GM SERVICE AND PARTS OPERATIONS
DCS1583
URGENT - DISTRIBUTE IMMEDIATELY

Subject: 06029A - Product Safety Recall
Rear Suspension Weld Separation
Service Procedure Revision

Models: 2005 Cadillac SRX and STS

SUBJECT: Rear Suspension Weld Separation

1816834

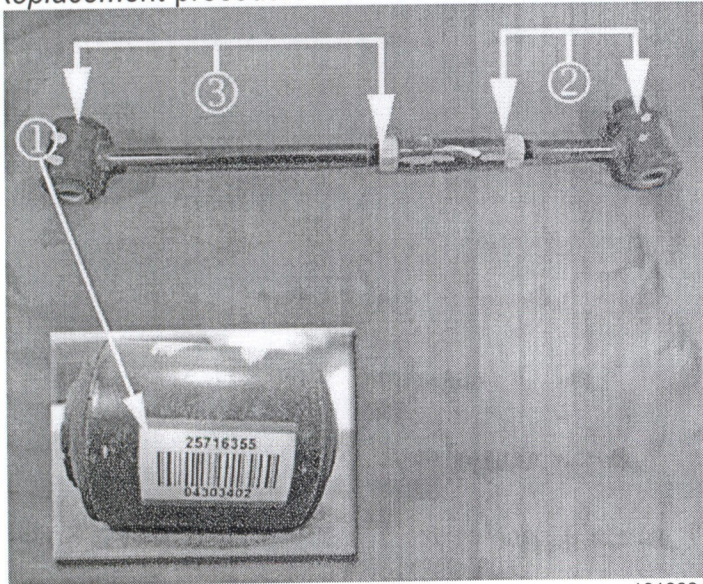
The service procedure in this bulletin has been revised. There are two labels on the adjustment link; one on the short end and one on the long end. The label that requires inspection is the label on the long end (inboard side). If the label is missing on the long end, replace the adjustment link. Please communicate this information to all technicians immediately. Discard all copies of bulletin 06029, issued May 2006.

Important: The adjustment link is installed to two locations of the rear suspension: The short end of the adjustment link is installed to the knuckle or (outboard) side (2). The long end of the adjustment link is installed to the frame or (inboard) side (3). The serial number (1) that requires inspection is located on label on the long end or inboard side (3) of the adjustment link. Refer to the illustration above. If the label is missing, replace the adjustment link. All toe link serial numbers are to be recorded on the R.O. and transferred to the *Comments* section when submitting the claim.

2. Locate and record the serial numbers (1) found on the adjustment links. The serial number is the bottom number. If the label is missing, replace the adjustment link.
3. Determine if the adjustment links must be replaced. The serial numbers of the adjustment links requiring replacement are below.

Serial Numbers of Adjustment Links Requiring Replacement
04122369 through 04122766
04122820 through 04123413

- If the serial numbers on the adjustment links are NOT within the ranges above, the adjustment links do not need replacing. Reinstall the adjustment links. Refer to the *Adjustment Link Replacement* procedure for 2005 Cadillac STS or SRX in SI. A wheel alignment is not necessary.
- If the serial numbers on the adjustment links ARE within the ranges above or the label is missing, replace the adjustment link. Refer to the *Adjustment Link Replacement* procedure for 2005 Cadillac STS or SRX in SI. Perform a wheel alignment. Refer to the *Rear Toe Adjustment* procedure for 2005 Cadillac STS or SRX in SI.
